BID PACKAGE MAY 1, 1988

TITLE
COURTS BUILDING
Fourth Floor Plan

GUILFORD COUNTY GOVERNMENTAL COMPLEX
HIGH POINT, N. C.

SHEET NO.
AC 1.5

FOURTH FLOOR PLAN

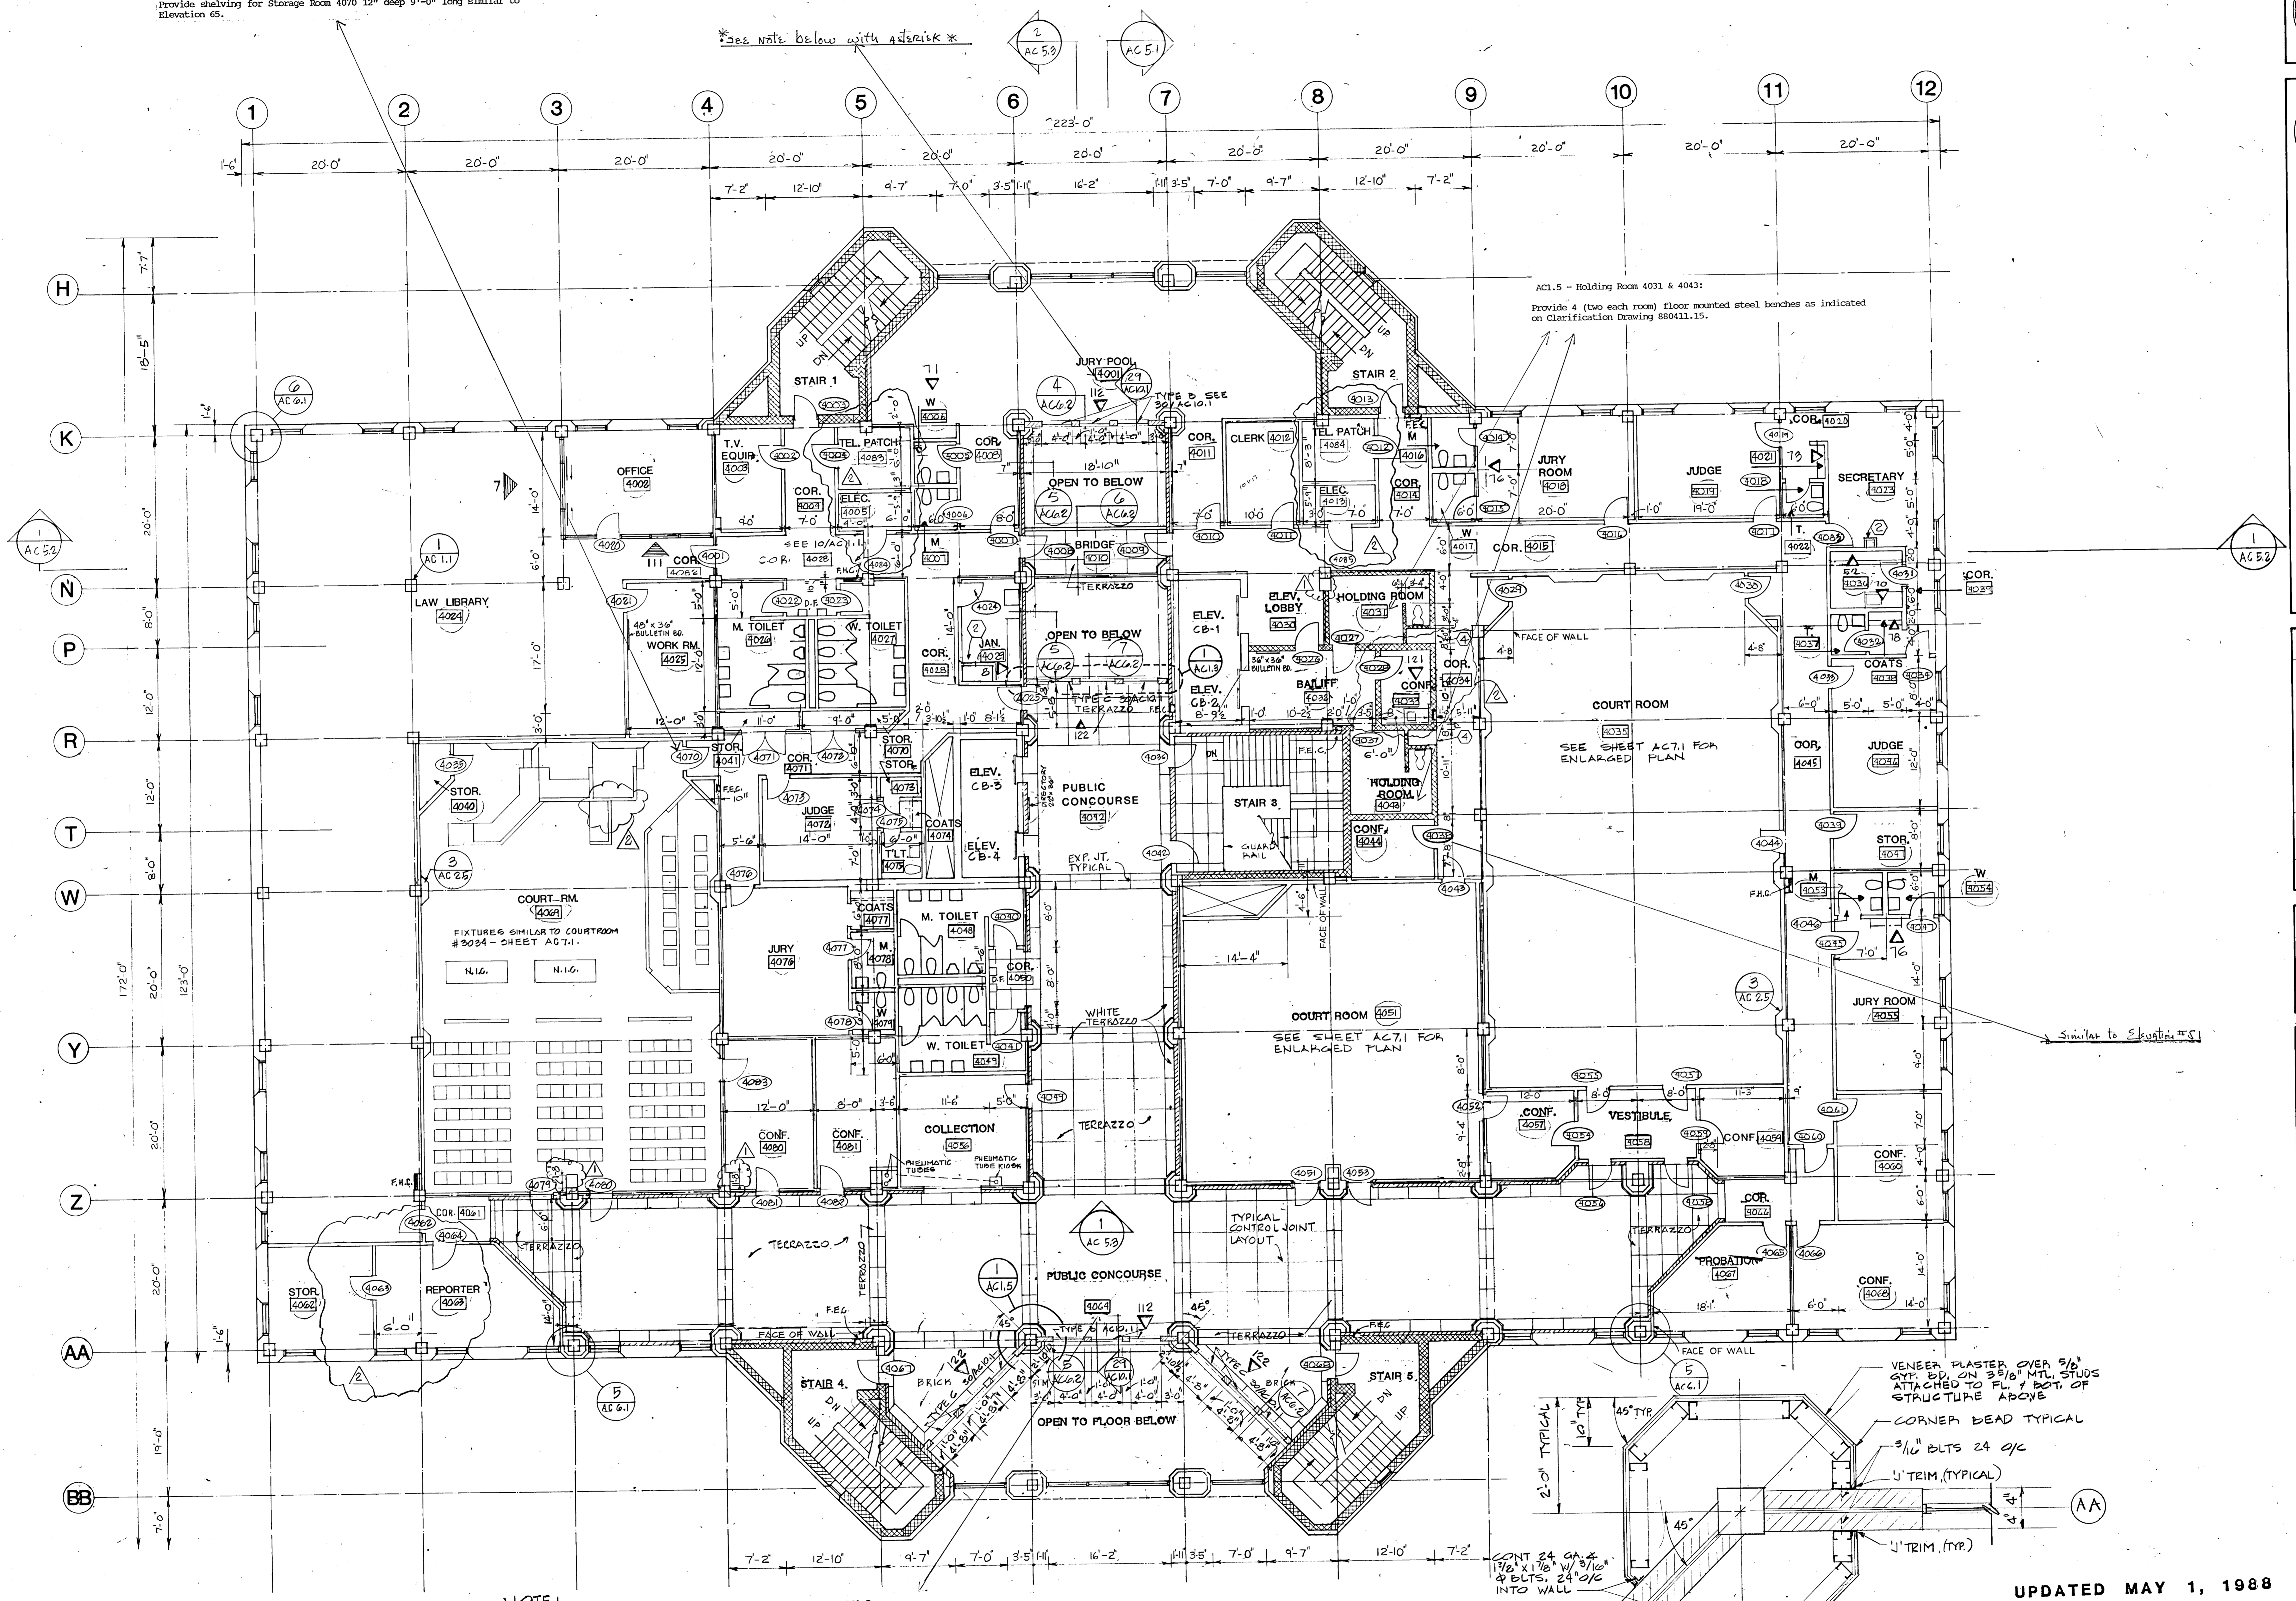
Provide shelving for Storage Room 4070 12" deep 9'-0" long similar to Elevation 65.

* Jury Pool 4001, east and west walls.*
Public Concourse 4064, south wall.

On sheets ACL.2, ACL.3, ACL.4, and ACL.5 in the spaces listed the Brick Masonry Contractor shall provide 16 gauge, 1 1/4" x 3 1/2" galvanized corrugated channel slot anchors at 16" vertically and 24" horizontally keyed into 16 gauge galvanized steel channel slots which shall be attached to existing masonry using 3/8" x 2 1/2" lap shield or 3/8" x 3" Lok/Bolt at 24" on centers. Channel slots shall be equal to Dur-O-Wall D/A 904, or Heckmann No. 133, or Southern Construction Products continuous type. Channel Slot Anchors shall be No. 912 as manufactured by one of the three manufacturers of the channel slots.
